CITY OF ALBUQUERQUE

Re: Barlow Shop
6205 Wilshire Ave NE
Traffic Circulation Layout
Engineer's/Architect's Stamp 12-11-19 (C18D070)

Based upon the information provided in your submittal received 2-3-20, the above referenced plan cannot be approved for Building Permit until the following comments are addressed:

Project number 019.12
Date 12-11-19
Drawn by BEM
Checked by CMO

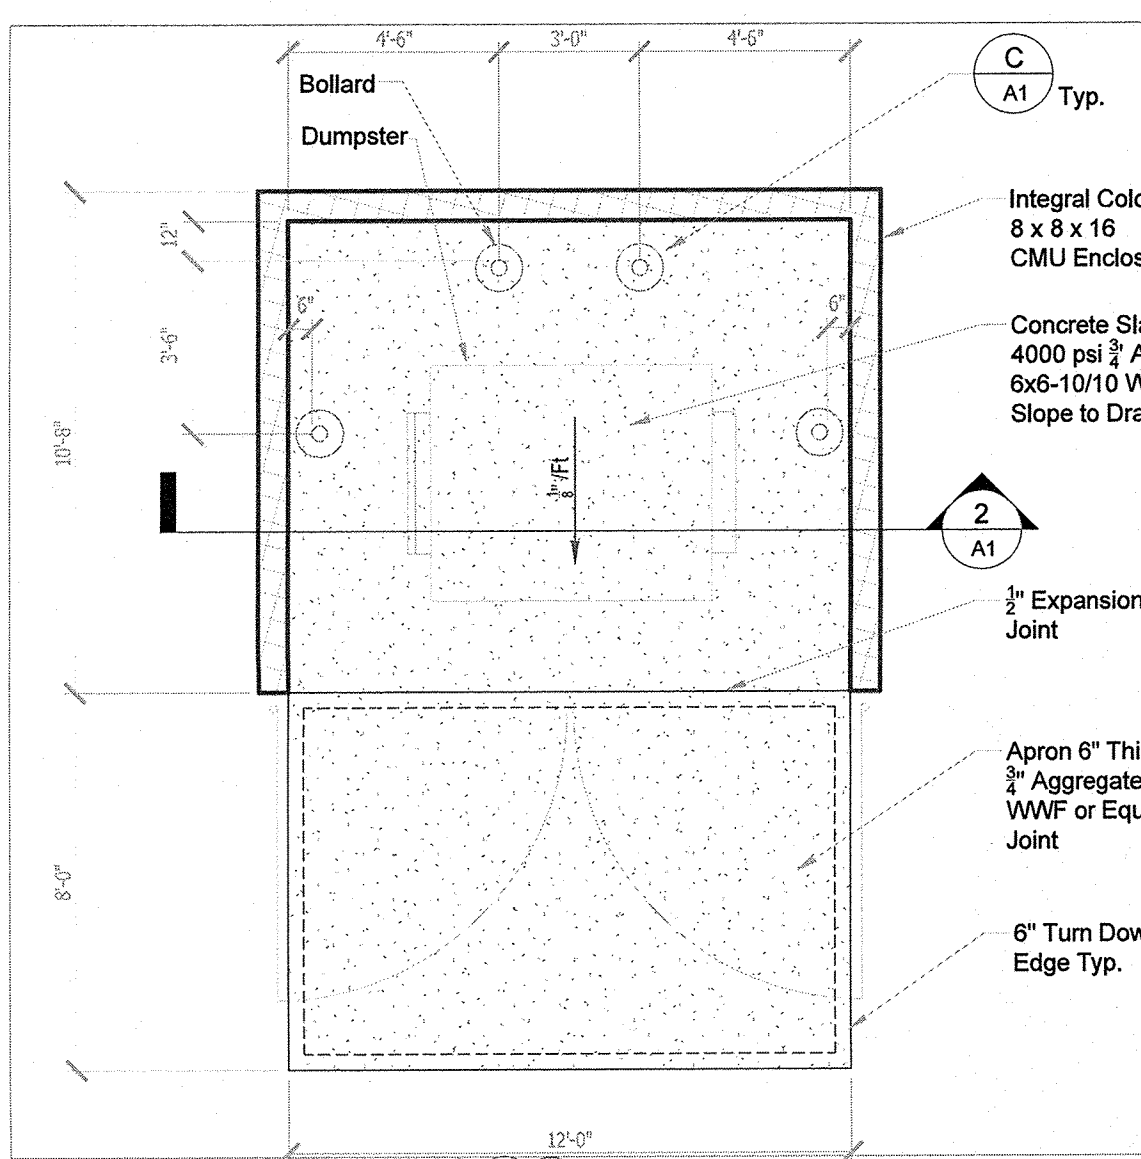
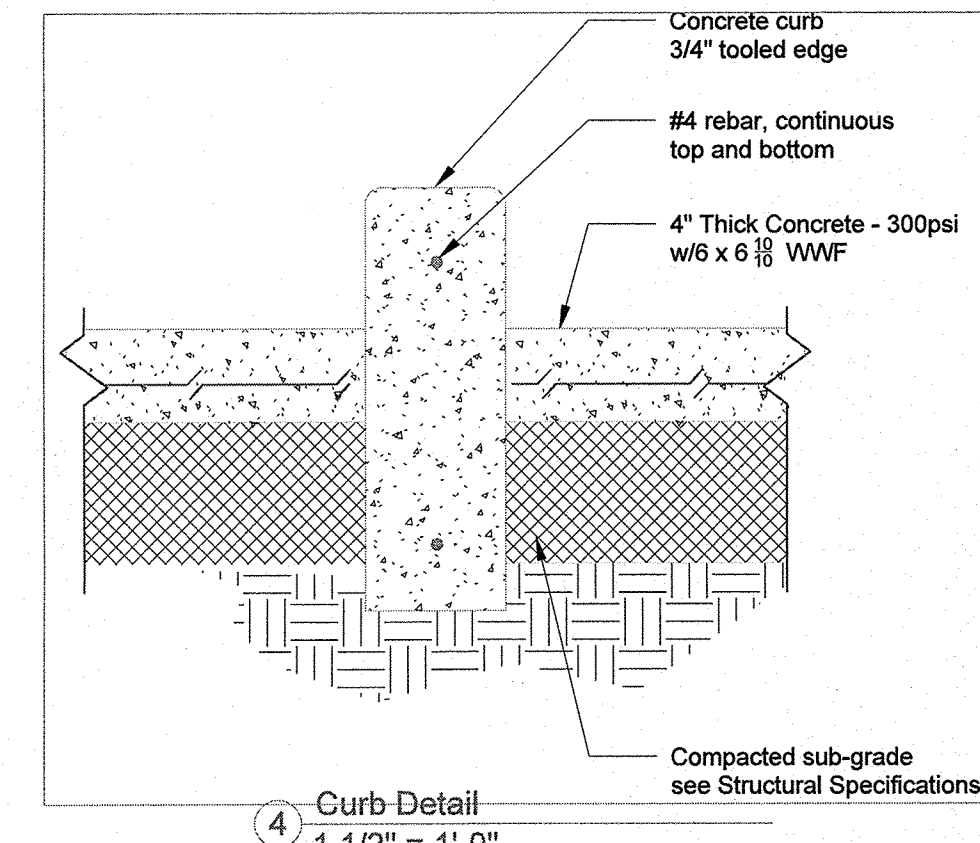
1. Please remove clouds on TCL Plan.
2. Please relocate Bike Rack, not allowed within parking stall.
3. All bicycle racks shall be designed according to the following guidelines:

- a. The rack shall be a minimum 30 inches tall and 18 inches wide.
 - b. The bicycle frame shall be supported horizontally at two or more places. Comb/toaster racks are not allowed.

- c. The rack shall be designed to support the bicycle in an upright position. See the IDO for additional information.
 - d. The rack allows varying bicycle frame sizes and styles to be attached.

- e. The user is not required to lift the bicycle onto the bicycle rack.
 - f. Each bicycle parking space is accessible without moving another bicycle.

4. Bicycle racks shall be sturdy and anchored to a concrete pad.
5. A 1-foot clear zone around the bicycle parking stall shall be provided.
6. Bicycle parking spaces shall be at least 6 feet long and 2 feet wide.

Once corrections are complete please deliver TCL to front counter. No Resubmittal required. Minor Corrections.
